Murad Apparels Ltd (Extension)

South Gouripur Ashulia, Savar, Dhaka-1341

21-Sep-2023

Buildings Information

Stress in column exceeds normal design limit

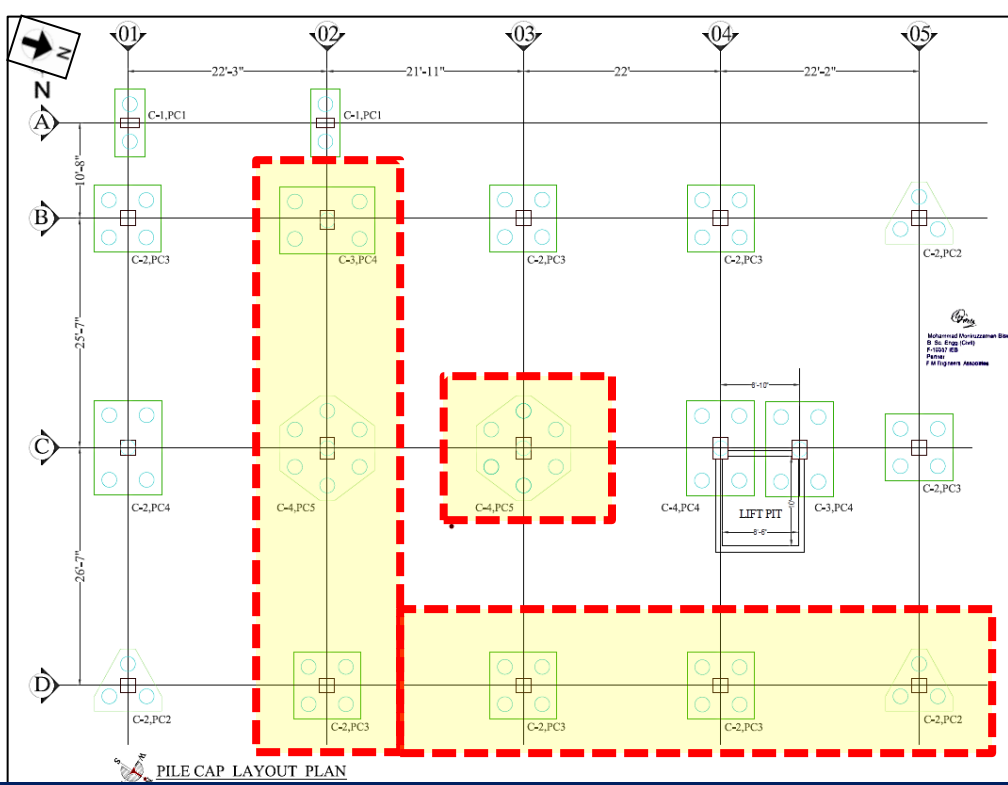
The cursory calculation indicates that column stress exceeds the normal design limit considering a typical floor live load of 6kPa, roof live load of 1.5 kPa, and concrete strength of 16.31 MPa. The building engineer is required to review the design, loads, and column stresses for the marked columns based on in-situ material strength.

Item No.	Observation	Recommended Action Plan	Recommended Timeline
01	Stress in column exceeds normal design limit (Godown Building-1)	Building Engineer to review design, loads and column stresses in the area identified above.	6-weeks
02	Stress in column exceeds normal design limit (Godown Building-1)	Verify in-situ concrete stresses by 100mm dia. cores from a minimum 4 nos from lower tier columns.	6-weeks
03	Stress in column exceeds normal design limit (Godown Building-1)	Produce and actively manage a loading plan for all floor plates considering floor and column capacity.	6-weeks
04	Stress in column exceeds normal design limit (Godown Building-1)	Carry out remedial works where required.	6-months
05	Stress in column exceeds normal design limit (Godown Building-1)	Continue to implement floor loading plan.	6-months

Pile layout plan

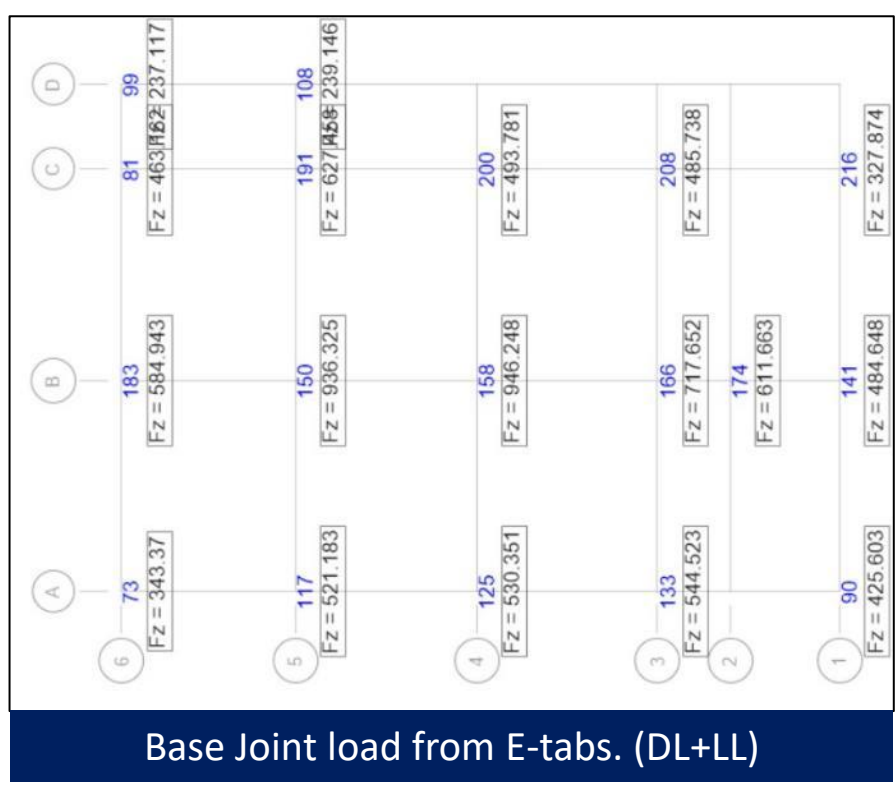
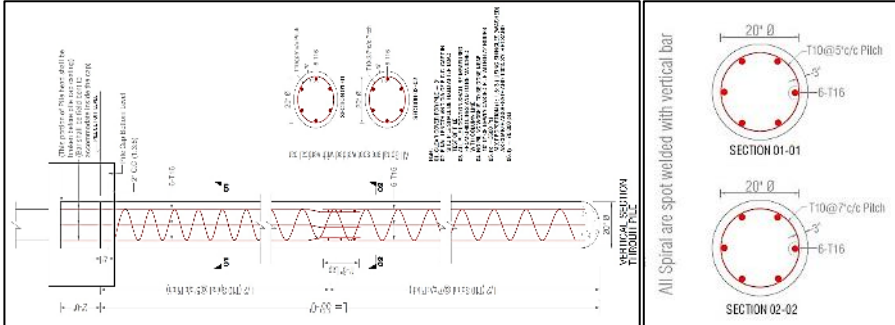
Stress in pile foundations exceed normal design limit

Cursory calculation indicates that Factor of Safety of some pile foundations below the allowable limit considering pile capacity from the soil test report and 6 kPa (63psf) live load on for storage. Building engineer is required to review the design load and stress in the pile foundations.

Item No.	Observation	Recommended Action Plan	Recommended Timeline
06	Stress in pile foundations exceed normal design limit (Godown Building-1)	Building engineer is required to review the design load and adequacy of the pile foundations and suggest necessary remedial actions accordingly.	6-weeks
07	Stress in pile foundations exceed normal design limit (Godown Building-1)	Carry out suggested remedial works where necessary.	6-months
08	Live load consideration and assignment. (Godown Building-1)	Building engineer to revise the Engineering Assessment (EA) including a design report, and a set of structural drawings in compliance with section 1.9.1.1 and section 1.9.1.2 as per BNBC.	6-weeks
09	Live load consideration and assignment. (Godown Building-1)	Produce and actively manage a loading plan for all floor plates within the factory, considering floor, column and foundation capacity.	6-weeks
10	Live load consideration and assignment. (Godown Building-1)	Continue to implement loading plan.	6-months

Live load consideration and assignment

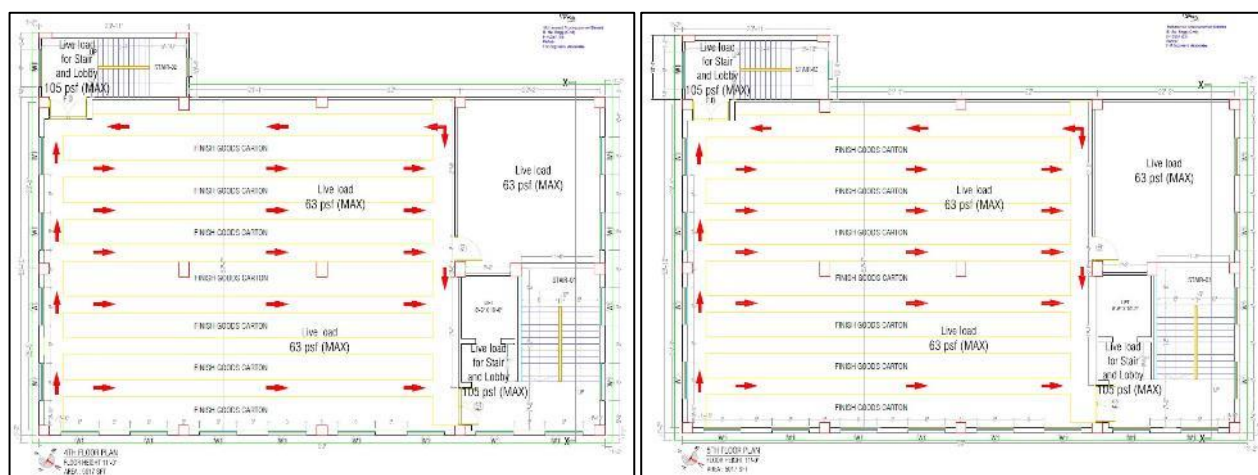
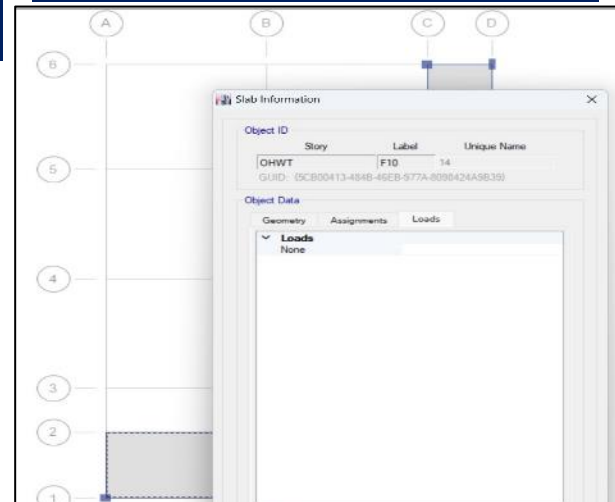
Prepared load plan for 4th and 5th floors. Floor loading has been considered 3kPa (63 psf) instead of 6kPa (125 psf) for storage areas.

Loading at 4th & 5th Floor loading has been assigned 3 kPa (63 psf) in FEA model instead of 6kPa (125 psf).

The stair roof top loading has not been assigned in FEA model.

As per BNBC, 6 kPa is required to consider as floor loading for the light storage facilities. During inspection, load plan was found posted considering (63 psf) 3kPa at 5th floor. Revise the software-based analysis model, Engineering Assessment (EA) report and load plan following BNBC requirements.

Rack on floor level

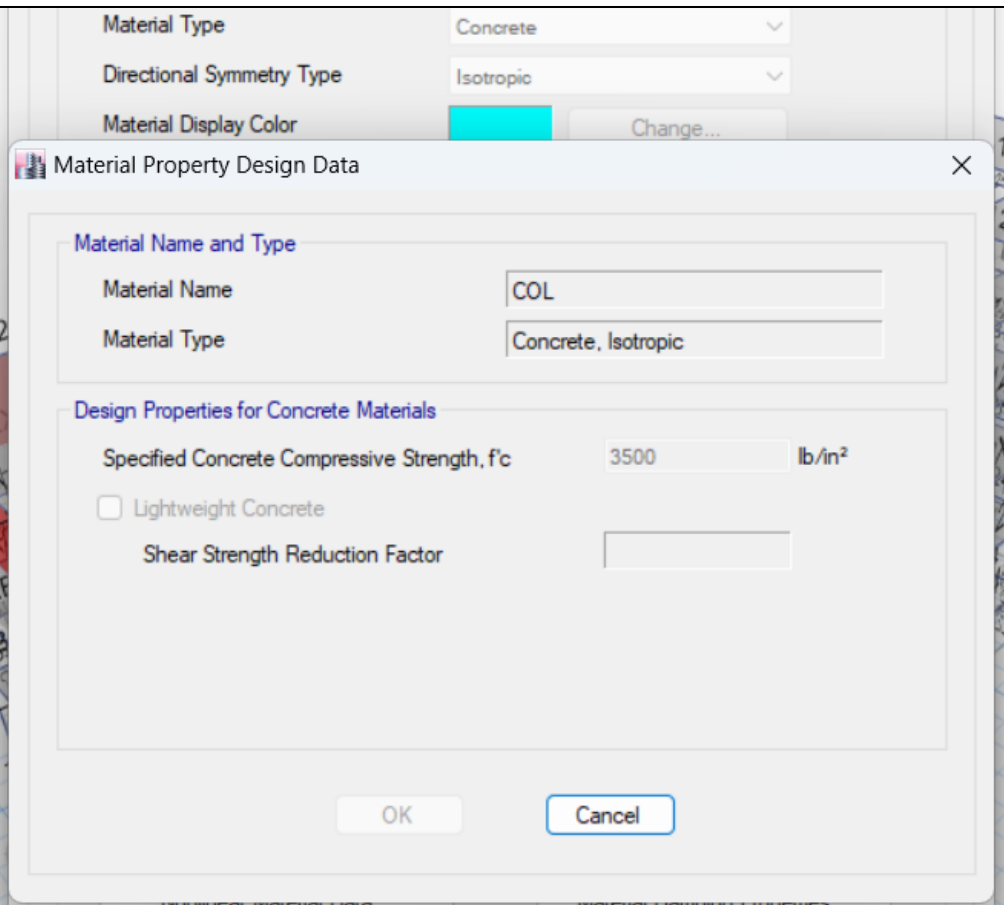
Racks on different floors are not adequately anchored or braced to resist lateral (earthquake) forces. Building is required to adequately anchor and brace all non-structural elements to resist earthquake forces to comply with the BNBC.

Item No.	Observation	Recommended Action Plan	Recommended Timeline
11	Non-structural elements not anchored or braced (Godown Building-1)	Building engineer is required to adequately anchor and brace all non-structural elements to resist earthquake forces to comply with the BNBC.	6-weeks
12	Detail Engineering Assessment (DEA) needs to be performed before Future Vertical Extension (Godown Building-2)	Prior to the vertical extension, building engineer is required to produce a Detailed Engineering Assessment(DEA) of the structure according to BNBC and submit it to RSC for review.	6-weeks
13	Detail Engineering Assessment (DEA) needs to be performed before Future Vertical Extension (Godown Building-2)	Carry out recommendation as outcome of the DEA.	6-months
14	Lack of edge protection (Godown Building-2)	Building is required to provide edge protection on the roof and stair to avoid falling hazard.	6-weeks

1.4 Material Specifications

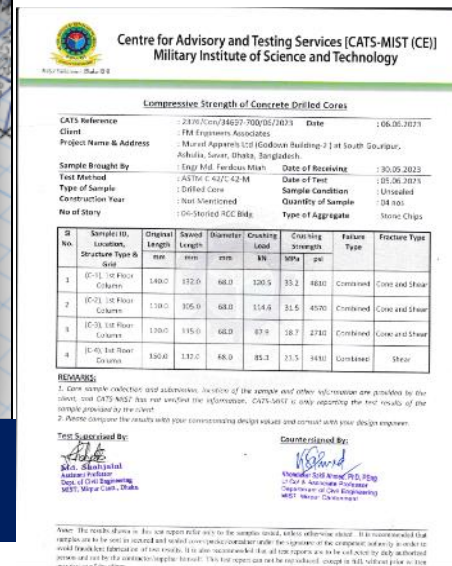
In software analysis, the concrete strength of columns considered $f'c=3500$ psi.

In report concrete strength of column has been considered $f'c=3500$ psi.

Compressive strength of concrete cores are 4810 Psi, 4570Psi, 2710 Psi, 3410 Psi

Building engineer has taken the concrete core from the column. The equivalent concrete strength was found 2739 psi following ACI-562 and considering ACI-214 correction the equivalent concrete strength was found 3068 psi which is below the design strength 3500 psi. Building engineer is required to perform a detailed engineering assessment considering the equivalent concrete strength of the column concrete core.

Lack of edge protection

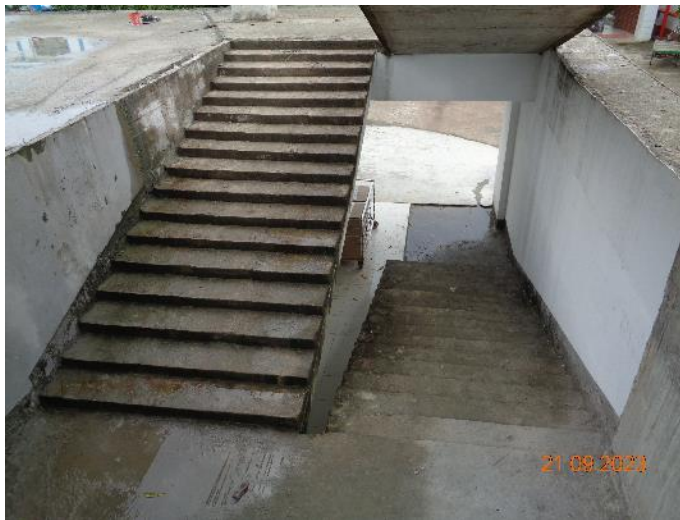
Missing railing at stair

Parapet wall missing at roof

During the inspection, Edge protection (Parapet wall/Railing) was not observed on the roof and stairs. Building is required to provide edge protection to avoid falling hazards.
